### **REMARKS**

Appl. No. 10/805,824  
Amdt. Dated August 15, 2007  
Reply to Office Action of March 29, 2007  
ANNOTATED SHEET SHOWING CHANGES

FIG. 2

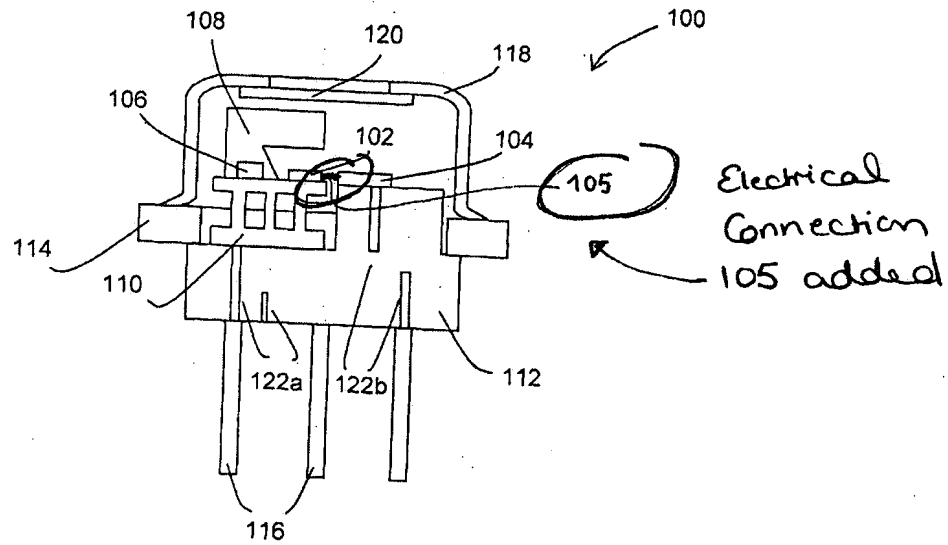
The Examiner also suggested amending Fig. 2 to depict an electrical connection from the upper portion of the upper surface of the substrate to the laser light source, and to amend the Abstract to conform to the language of independent claim 25 as amended.

Changes to Fig. 2 and to the Abstract have, as a result, been made in the instant Amendment. The changes to Fig. 2 submitted herein include the depiction of the electrical connection or "leads" mentioned in paragraph [0020] of the original specification. To the extent that the electrical connection is being added herein to Fig. 2 and supplied with a reference numeral "105" therein, paragraph [0020] of the specification is being sought to be amended herein to specifically mention reference numeral "105" as corresponding to the "leads" mentioned in that paragraph.

The attached sheet of drawings includes changes to Fig. 2. This sheet, which includes only Fig. 2 thereon, replaces the original sheet including Fig. 2. In Fig. 2, the previously omitted electrical connection from the upper portion of the upper surface of the substrate to the laser light source has been added.
